## *City of El Paso – City Plan Commission Staff Report*

**Case No:** SUSU13-00002 – Glenwood Circle Place  
**Application Type:** Resubdivision Combination  
**CPC Hearing Date:** July 25, 2013  
**Staff Planner:** Nelson Ortiz, (915) 541-4931, [ortiznx@elpasotexas.gov](mailto:ortiznx@elpasotexas.gov)  
**Location:** North of Border Highway and East of Glenwood  
**Acreage:** 2.03 acres  
**Rep District:** 8  
**Existing Use:** Vacant  
**Existing Zoning:** R-4 / SP (Residential/ Special Permit)  
**Proposed Zoning:** R-4 / SP (Residential/ Special Permit)  
**Nearest Park:** Ascarate Park (.181 mile)  
**Nearest School:** Clardy Elementary School (0.391 mile)  
**Park Fees Required:** ~~\$24,660.00~~ \$12,330.00  
**Impact Fee Area:** N/A  
**Property Owner:** Mario Ornelas  
**Applicant:** Aria Construction  
**Representative:** Dorado Engineering, Inc.

## ATTACHMENT 3

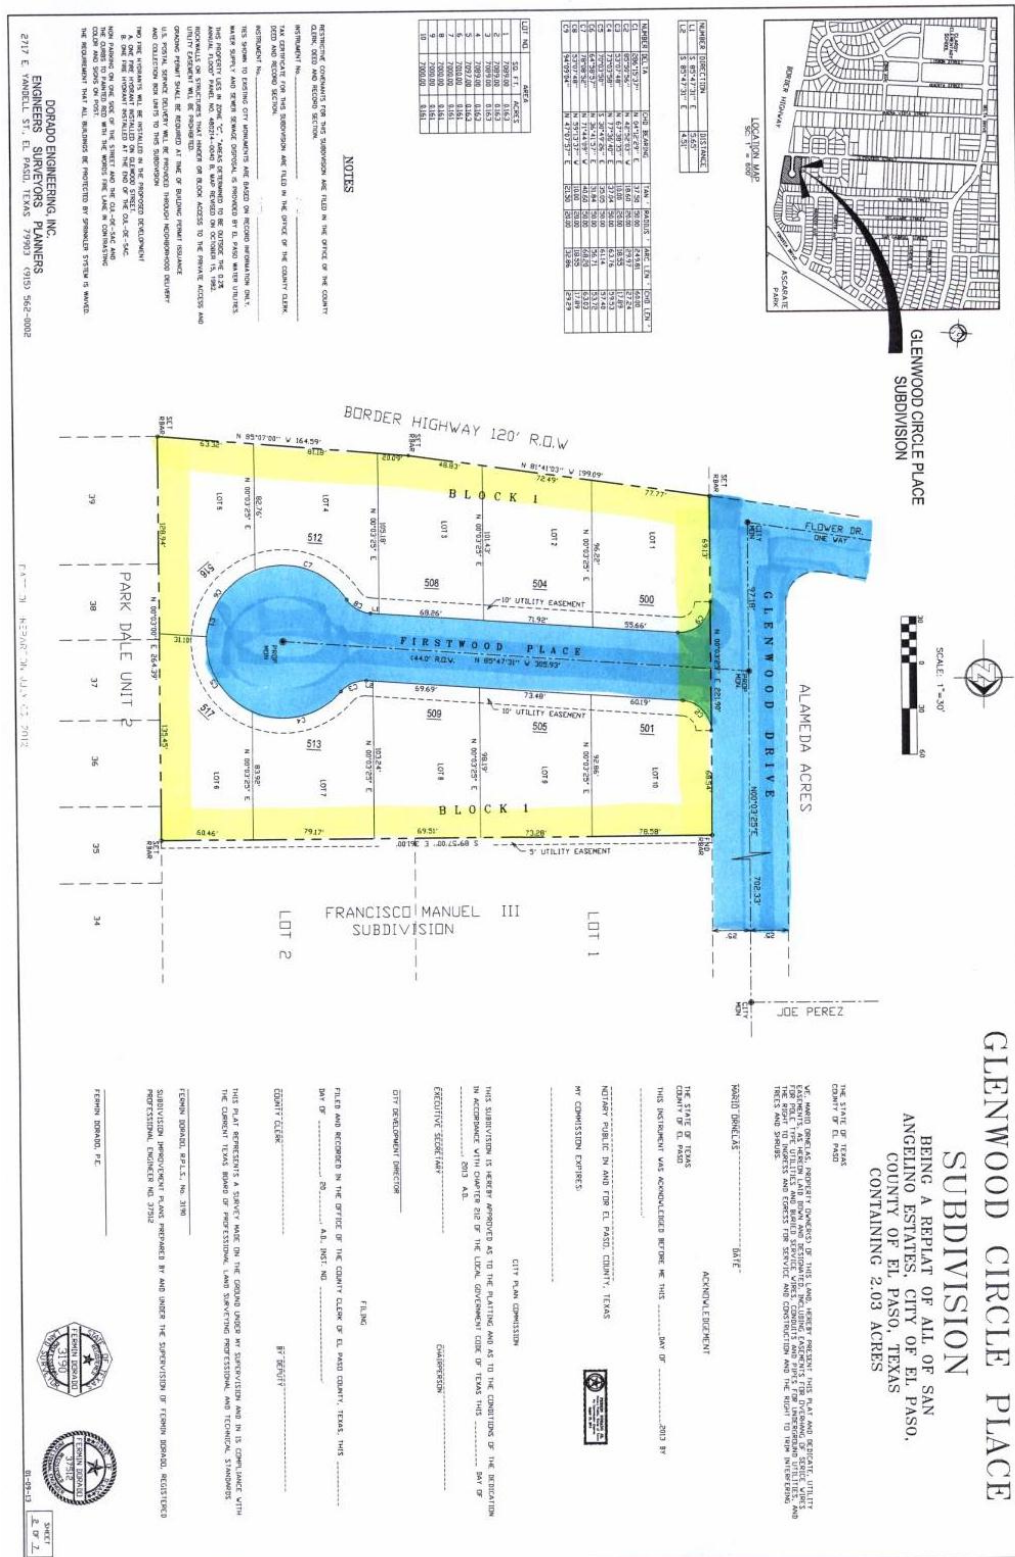
- To allow a 97.18-foot minimum offset distance in accordance with Section 19.15.120-(Street offsets).

Staff recommends **approval** of Glenwood Circle Place, alternative design and of the exception request. Section 19.15.120 states:

*The city manager or designee may grant an exception where **infill**, topographic or other physical features render the required off-set unnecessary or impractical.*

The name of the street in itself currently exists, therefore, even if connected to, and even if it has a different suffix, constitutes duplicity.

- The El Paso County 911 District **Requests** that another name be chosen for this street.
- The El Paso County 911 District requests that addressing is displayed on the plat for review while still in the preliminary stage.

*(Comments have been addressed by applicant.)*
